Hillside Copper Mine

Mining Lease Proposal Response Document

21 February 2014

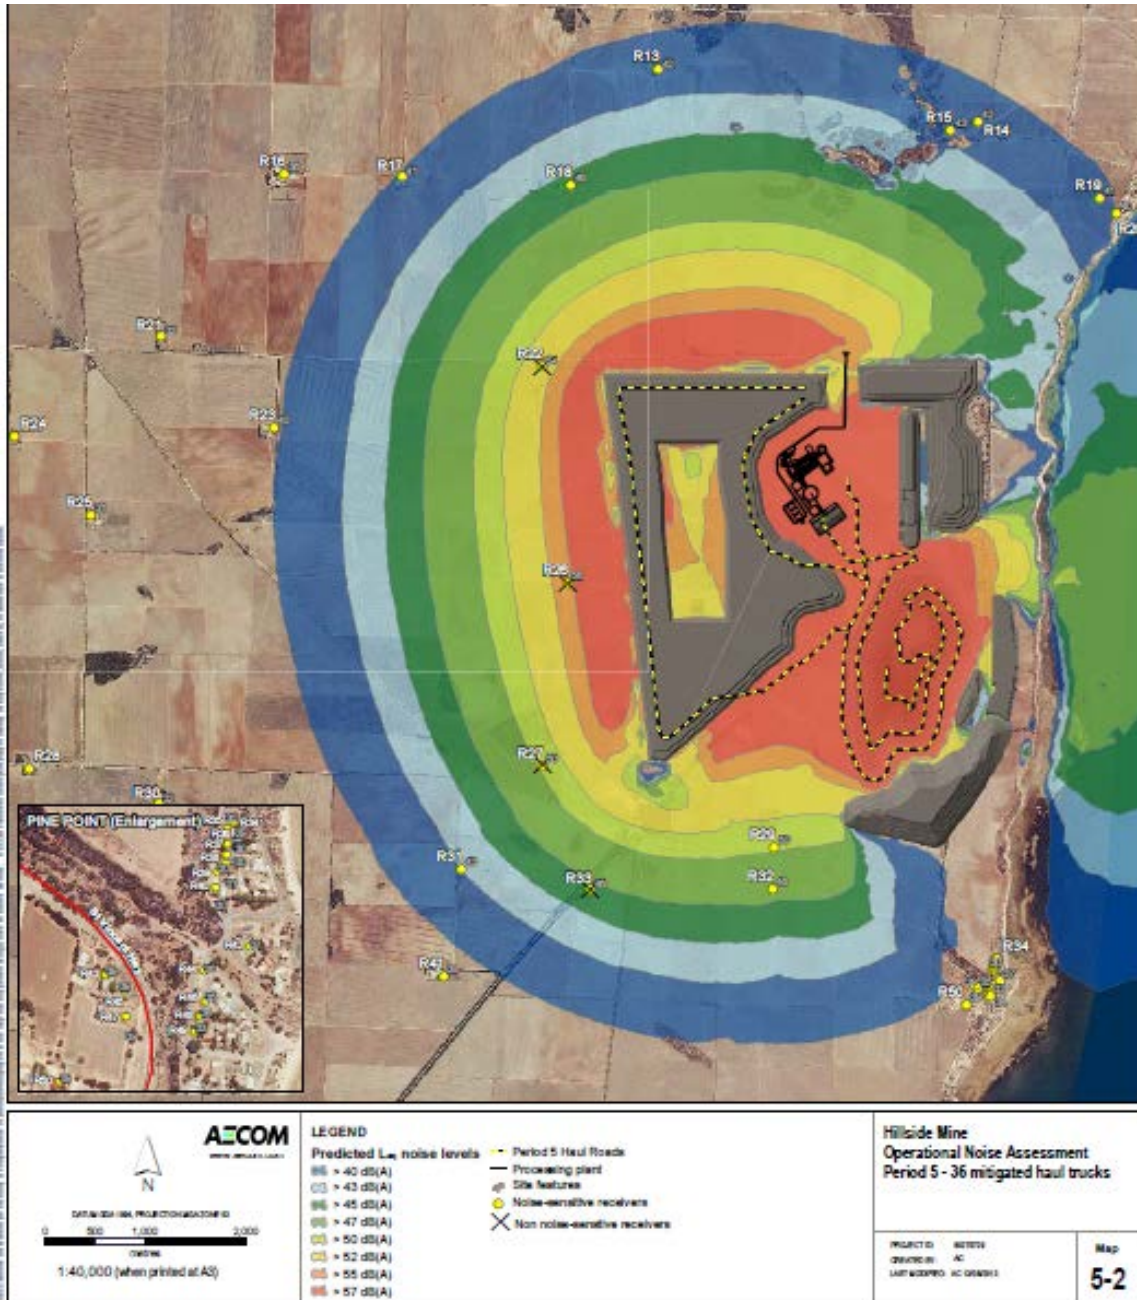
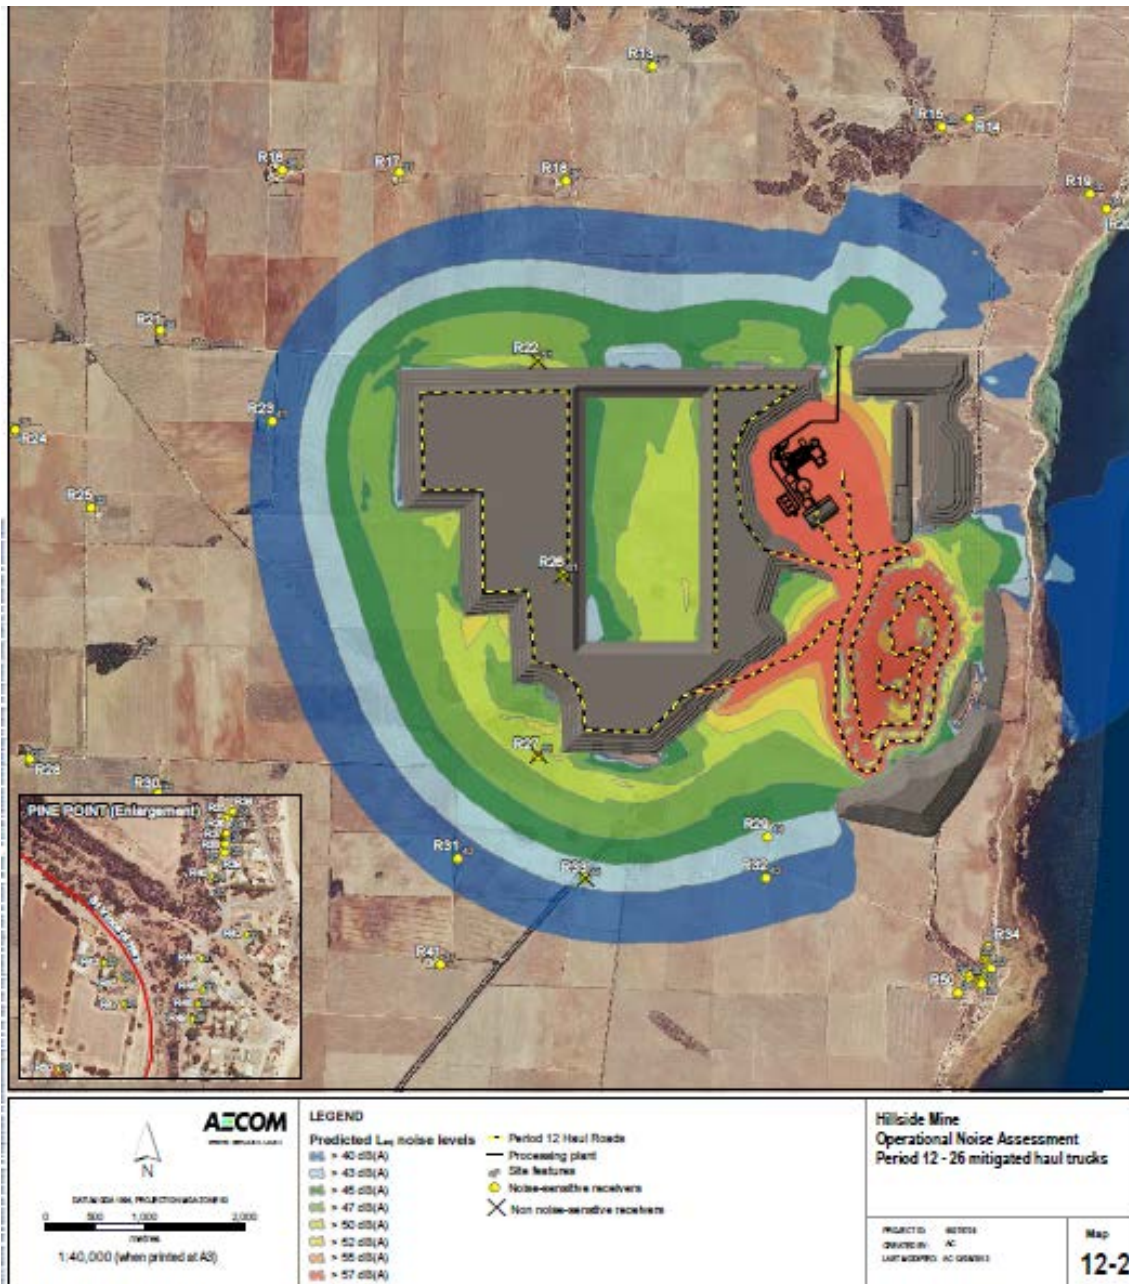
Explanation sought for why the tailings dam becomes much bigger in year 12 from year 5 in Figs. 7 & 8 on pgs. 16 & 18 in the Operational Noise Assessment. Does the noise modelling reflect the proposed design?

The noise model considers the change of the TSF from a high aspect to a low aspect as shown below in Figure 12-1 from Appendix 6.6-A of the MLP. 'Year 5' was modelled using the 'high aspect ratio TSF' as shown below in Figure 5-2. This was assessed by AECOM and considered to be representative of the operational footprint in year 5, regardless of the change to the height of the TSF. 'Year 12' was modelled using the 'low aspect ratio TSF' see Figure 12-2 presented below. The low aspect ratio TSF design for period 12 is the maximum TSF footprint as presented in the MLP. This modelled scenario is the worst case scenario for noise.

The worst case scenario is based on predicted noise levels that assume worst case meteorological conditions for noise propagation, corresponding to CONCAWE (Conservation of Clean Air and Water in Europe) Meteorological Category 6. This assumes emissions in the night time period and that there is less than 50 per cent cloud cover, with a light wind blowing (2-3 m/s) toward the receptor from the noise source direction and moderately stable atmospheric conditions, see Appendix 6.6-A of the MLP for further detail.
